SUBJECT: NuScale Power, LLC Supplemental Response to NRC Request for Additional Information No. 28 (eRAI No. 8771) on the NuScale Design Certification Application

NuScale Supplemental Response to NRC Request for Additional Information eRAI No. 8771

eRAI No.: 8771

NRC Question No.: 15-1

Figure 15.0-18: Reactor Power EDSS Available - Peak Power Case

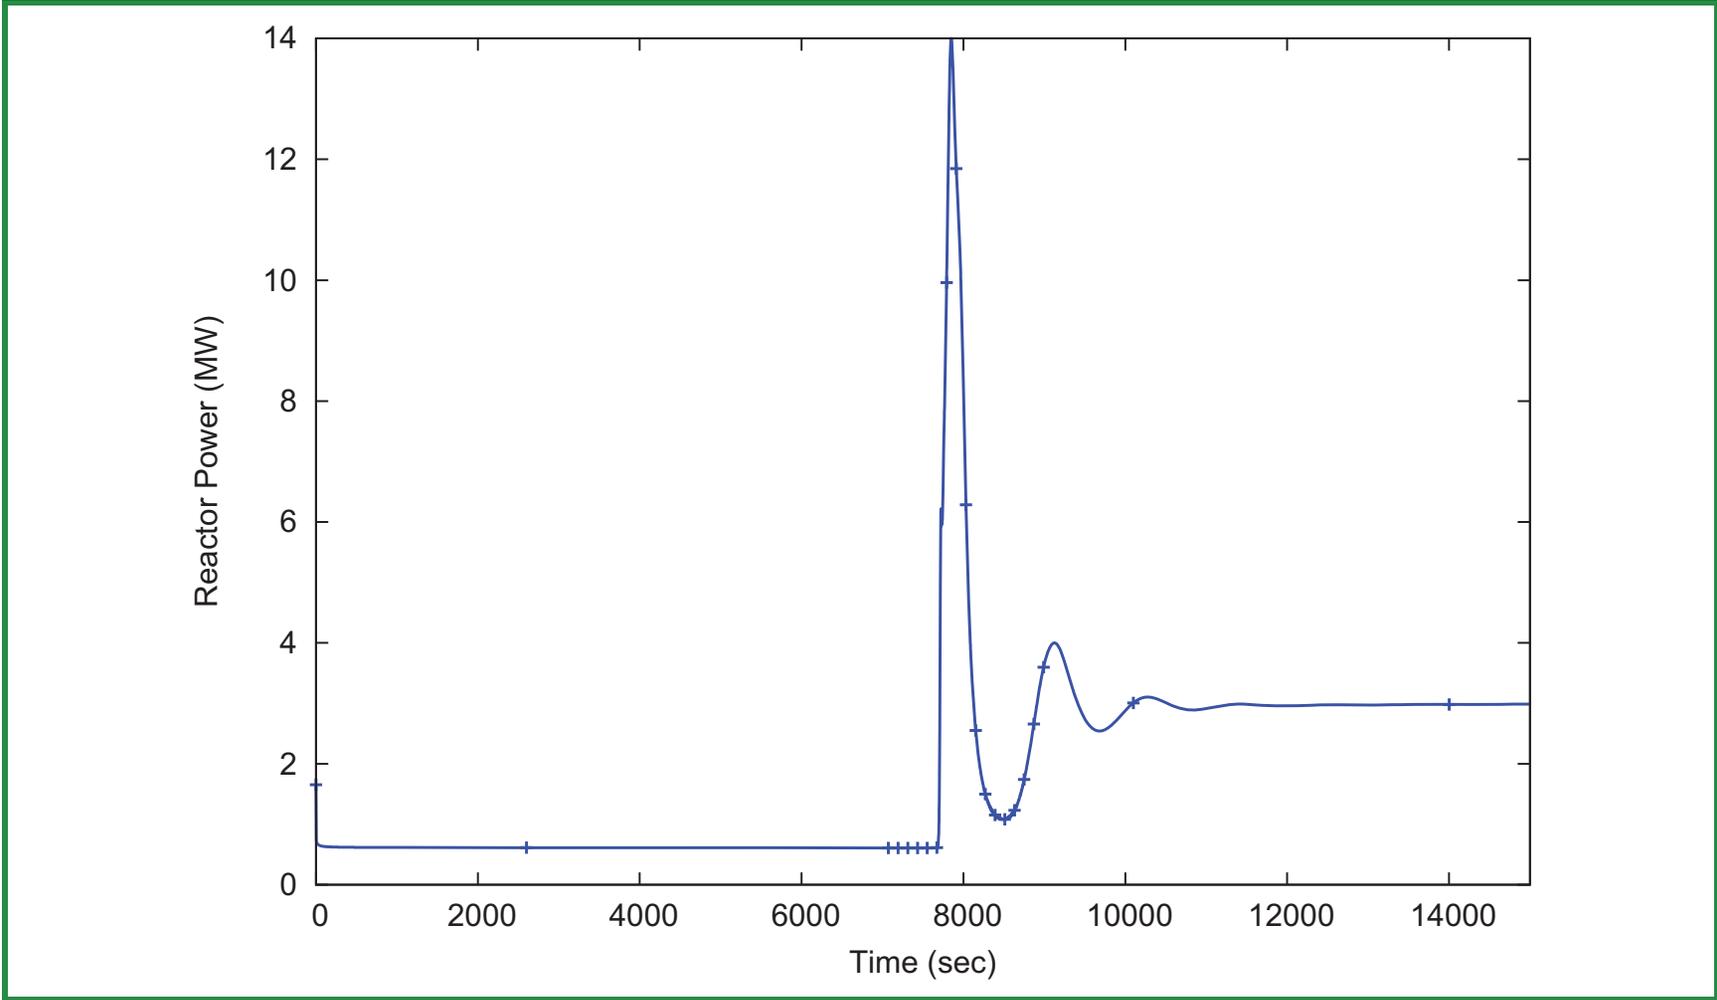
This response supplements the original response provided for this RAI question. In a December 5, 2017 public phone call to discuss the response to this RAI, the NRC staff indicated they believed the response only addressed one scenario associated with return to power upon ECCS actuation and not the return to power during the DHRS scenario.

In order to provide additional clarification, additional wording has been added to FSAR Section 15.0.6 and two additional figures, Figure 15.0-18 peak power with EDSS available and Figure 15.0-19 for RCS flow with EDSS available have been incorporated.

For the peak power case, recriticality occurs at 6750 seconds and the peak power (14 MW) occurs at 7850 seconds. As the temperature of the RCS increases, power decreases until equilibrium power (3 MW) is reached at 12000 seconds. This scenario results in the highest power level but is not limiting for MCHFR or other parameters. RCS Power is shown in Figure 15.0-18 and RCS flow in Figure 15.0-19.
